ADDENDUM NO.: 1  
 DATE OF CMR ADDENDUM: 2/10/14

<b>Project Name:</b>	New Academic Laboratory Building, SCSU
<b>Project Location:</b>	485 Fitch St. New Haven, CT
<b>Project Description:</b>	Bidding of work deferred (Rain Harvesting and Fire Caulking)
<b>Project Construction Budget:</b>	\$51,000,000
<b>CT DCS Project Number:</b>	BI-RS-283

**SCSU New Academic Laboratory Building  
Southern Connecticut State University, New Haven, CT  
BI – RS – 283**

# Rainwater Harvesting System: Flow Diagram & System Description

<b>RFI #</b> 00000215	Rainwater Harvesting System Clarifications	<b>1/30/2014</b>
-----------------------	--	------------------

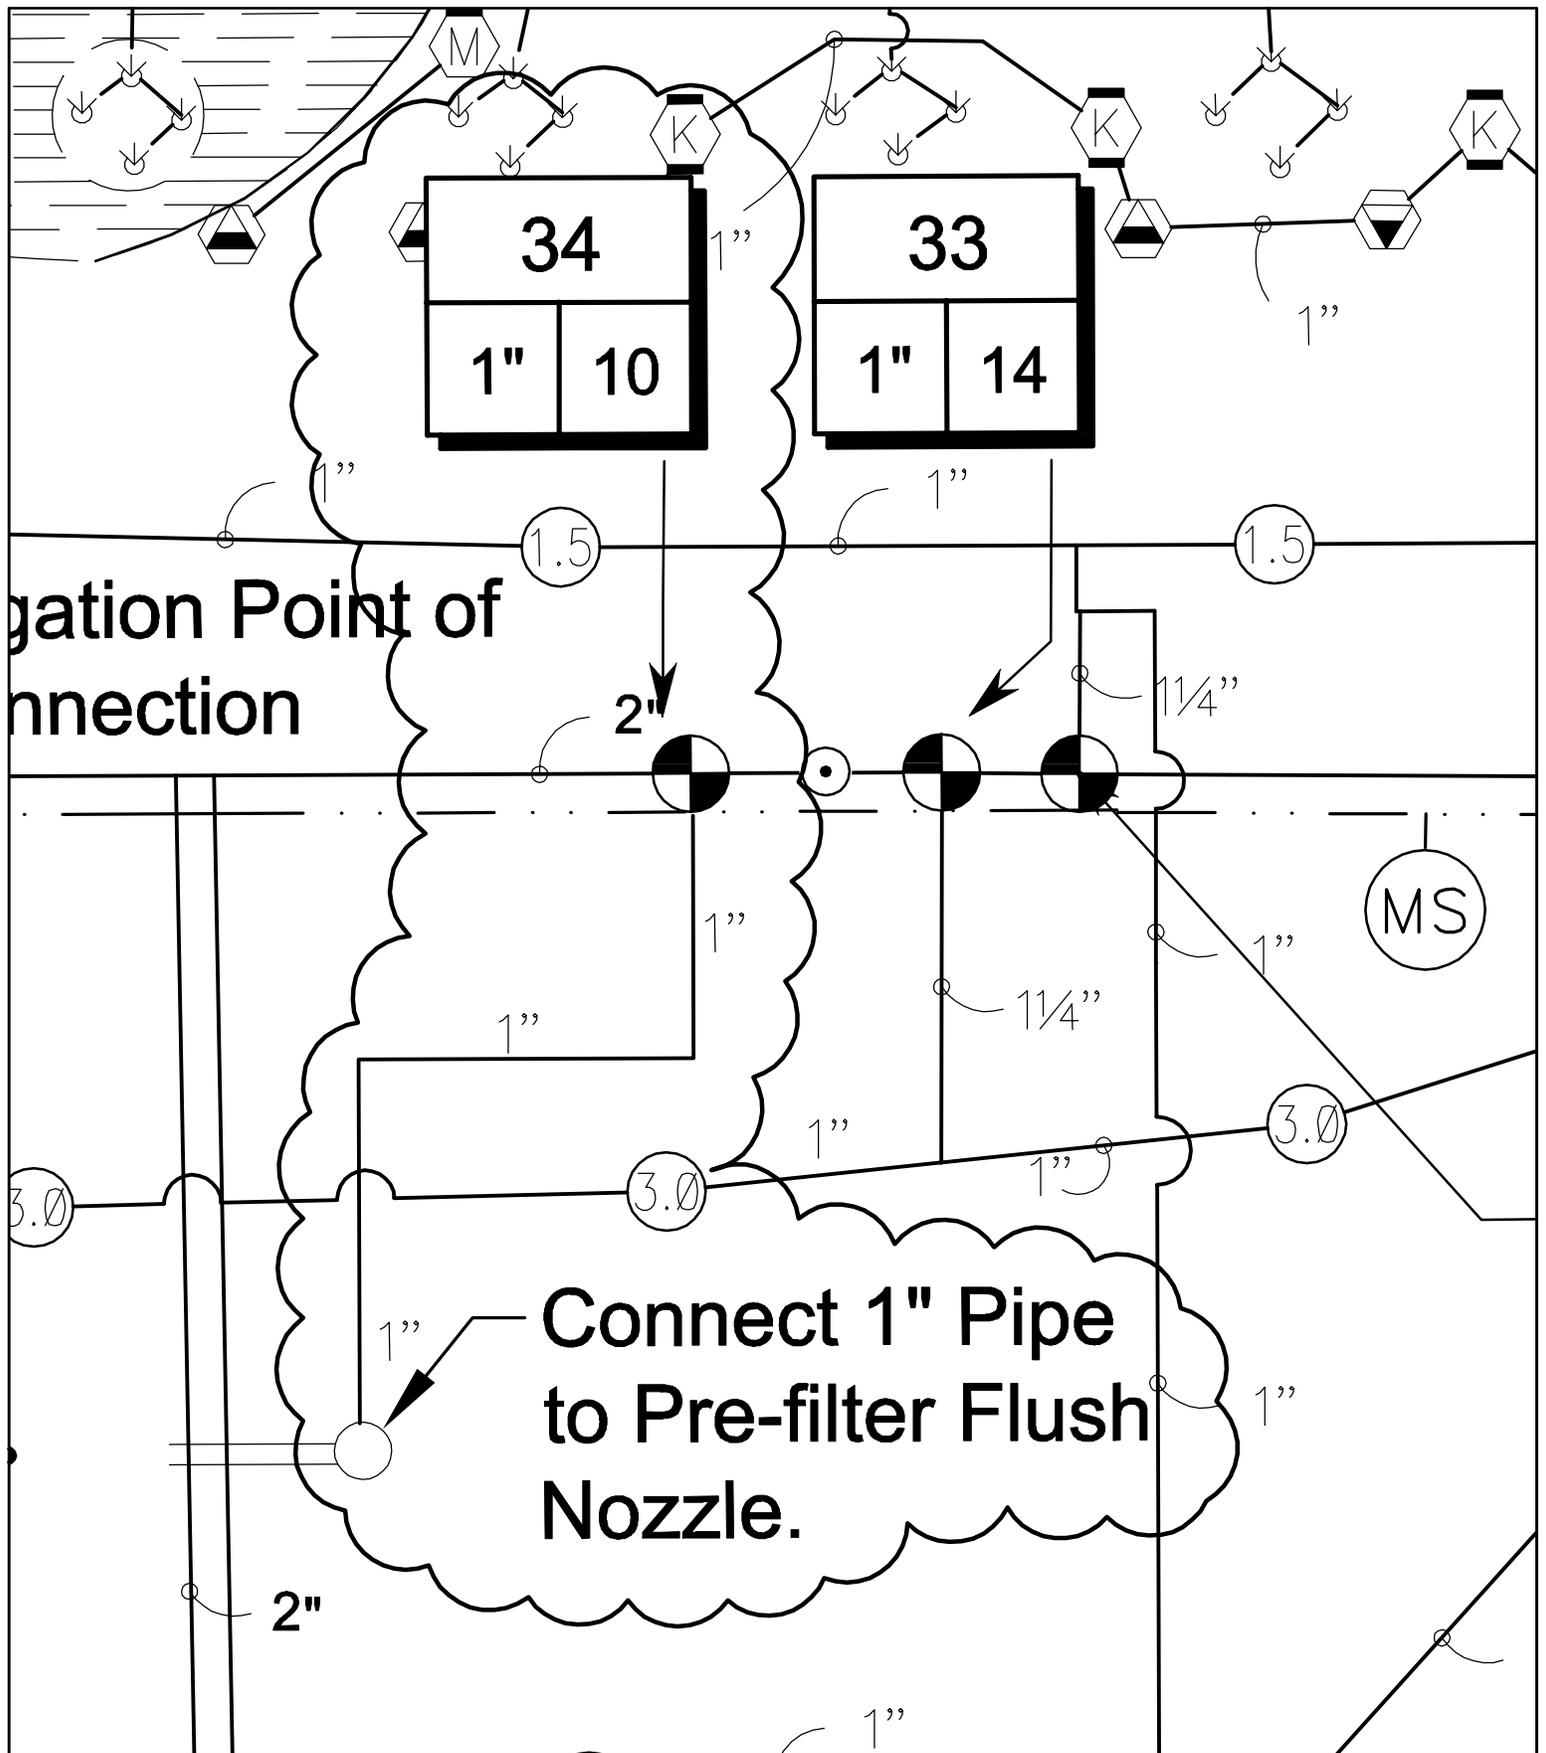
- Detail 1 on drawing IR-100 calls for 2" HDPE pipe to pump package which is assumed to be the pump discharge. However, details 2 & 3 on drawing IR-102 do not specify discharge size coming from pump, while the pump control package detail shows 3" connection from rainwater pump discharge. Please confirm size of pump discharge line.
- Pump control package detail on IR-102 shows 1" NPT to rainwater filter nozzle. There is no other reference to a rainwater filter nozzle in the drawings. Please provide a detail for location and piping requirements.

- Increase pump discharge pipe to 3". Pipe is to be 3" from pump to pump control package and 3" to irrigation system point of connection. (See SK2 attached)
- The 1" NPT to the pre-filter nozzle will be eliminated from the pump control package. In lieu of that the irrigation contractor will install another 1" automatic valve assemble (Zone #34) which will be connected to the pre-filter nozzle. The irrigation controller will operate this valve. (See SK1 attached)

**SK-1**

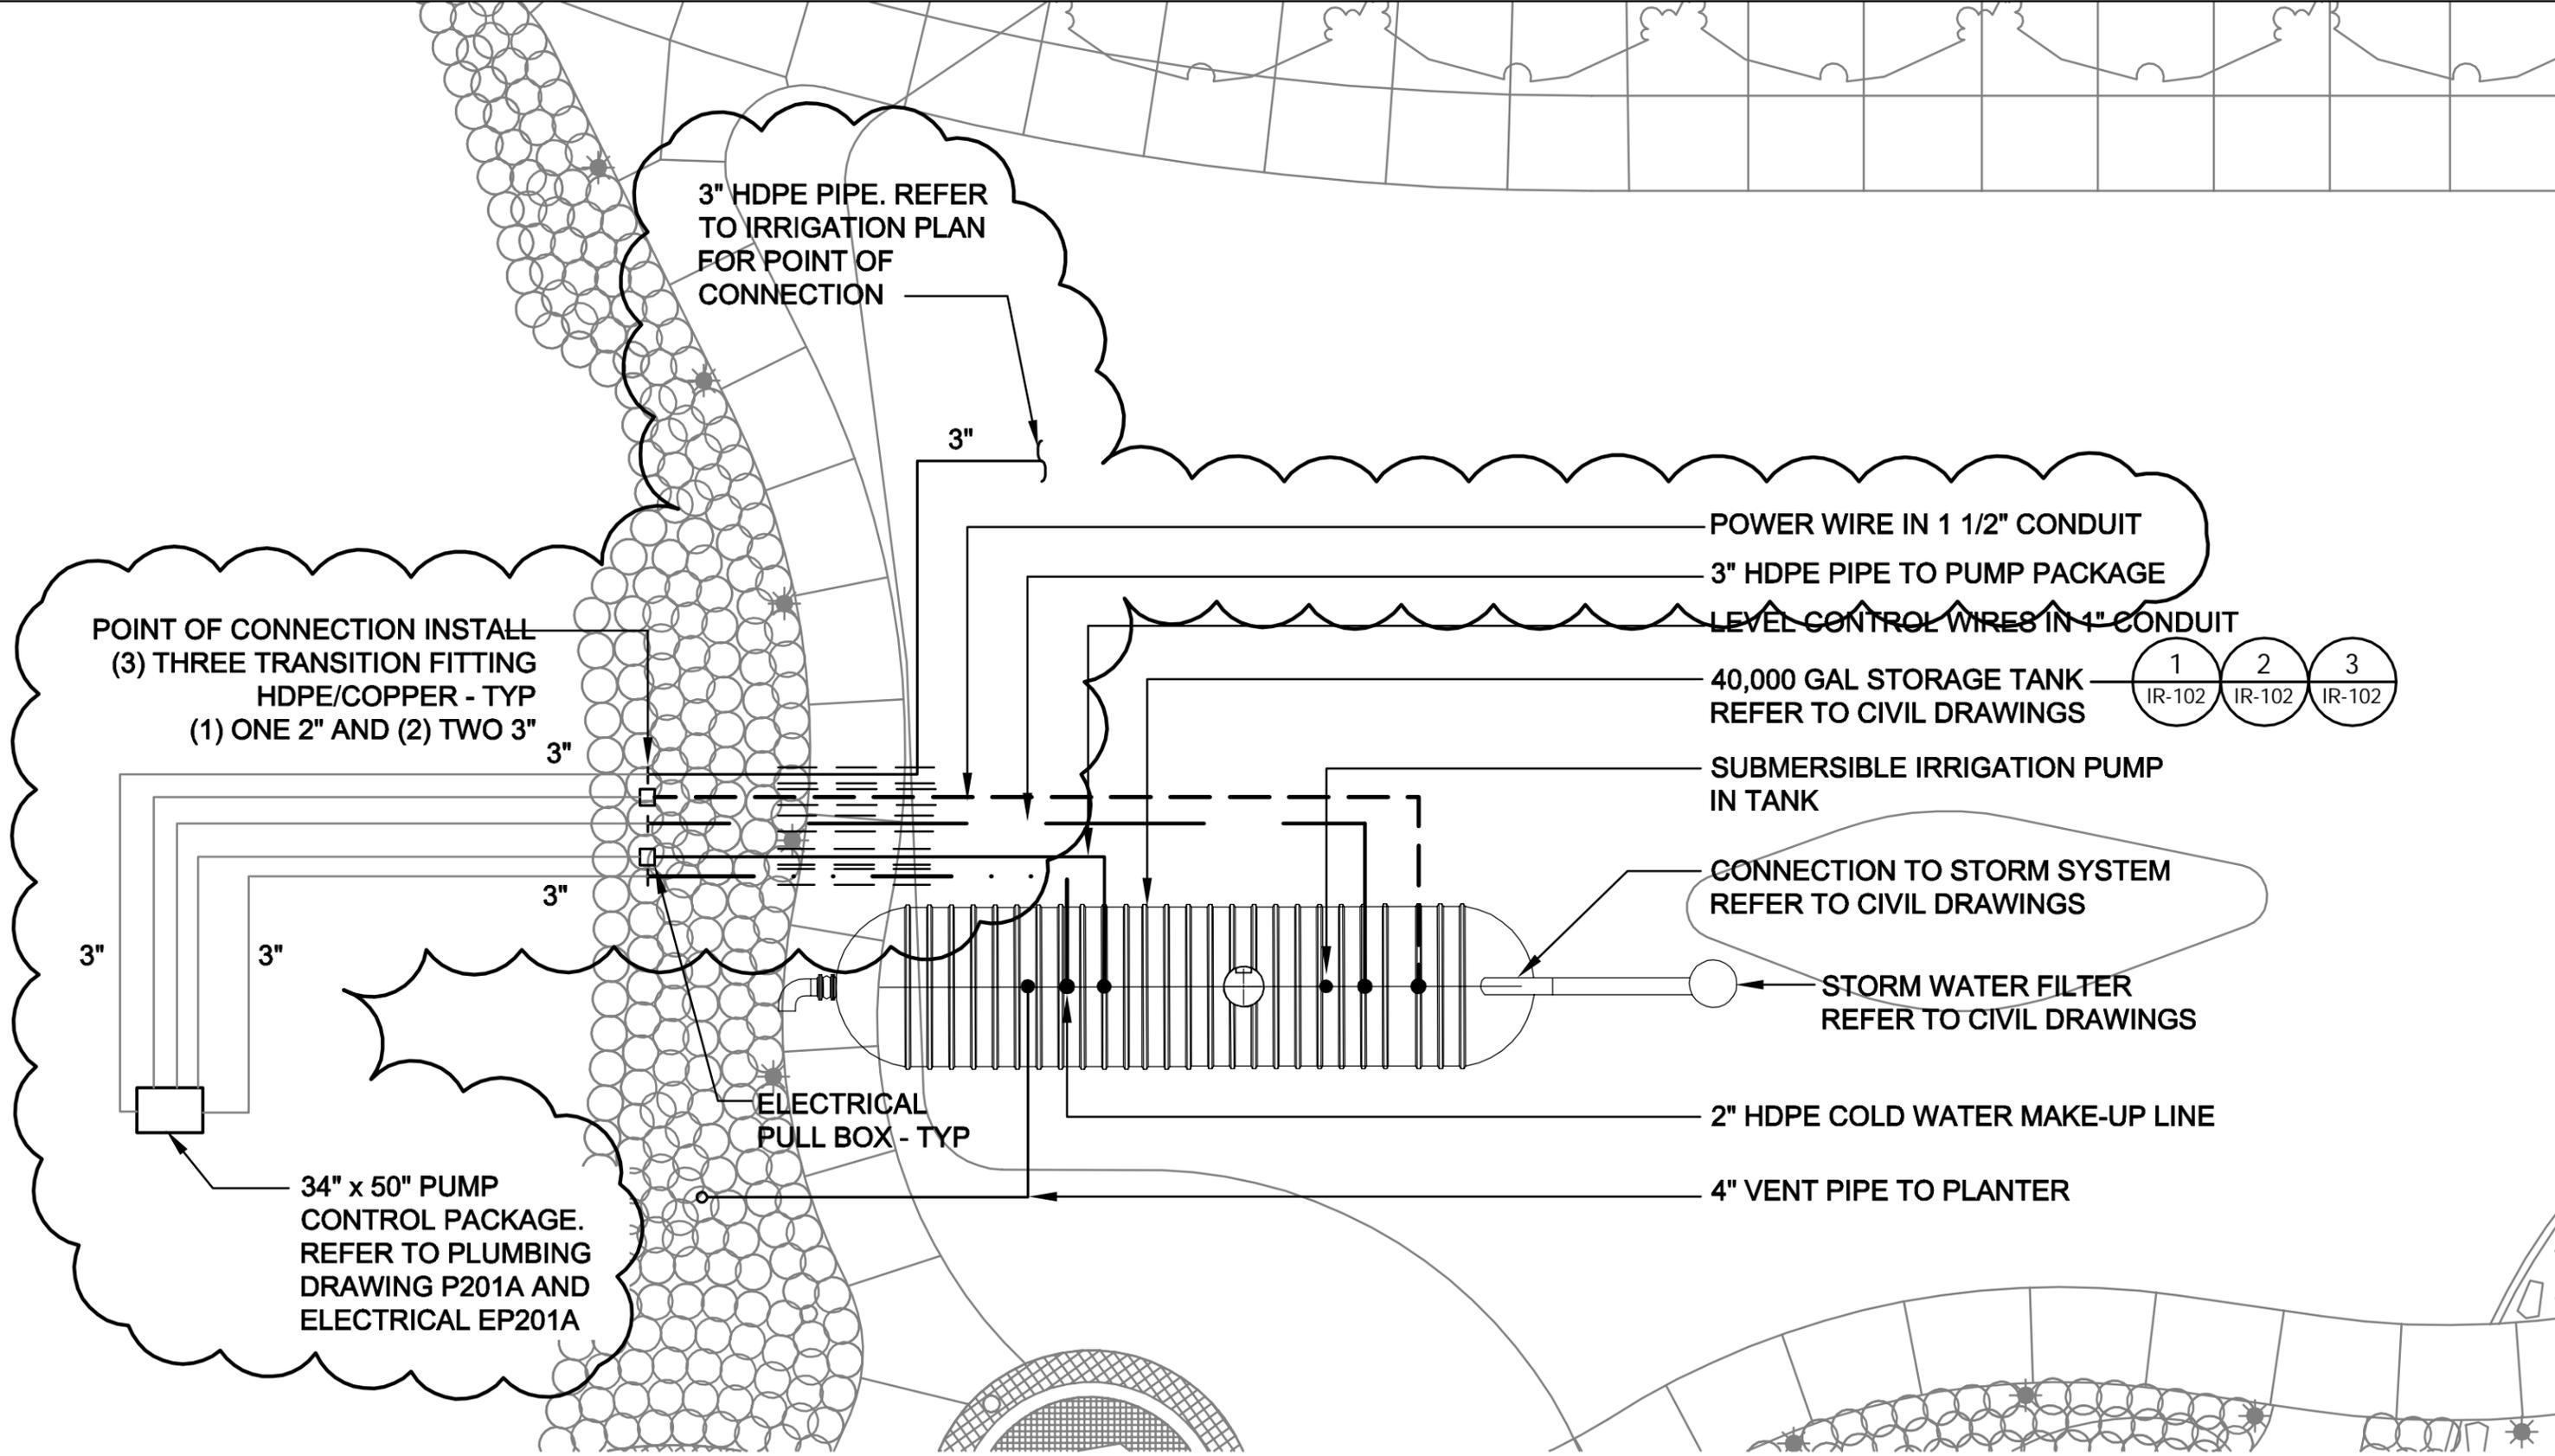
DWG#	DETAIL#	DESCRIPTION OF REVISION
IR 100	Irrigation Plan	Add 1" pipe connection to pre-filter flush nozzle as indicated on attached SK-1.
IR 100	Enlarged Irrigation Plan	Pipe, power, and fittings connections' clarifications as indicated on attached SK-2

Connect 1" Pipe  
to Pre-filter Flush  
Nozzle.

1" Automatic Valve Piped to Pre-Filter
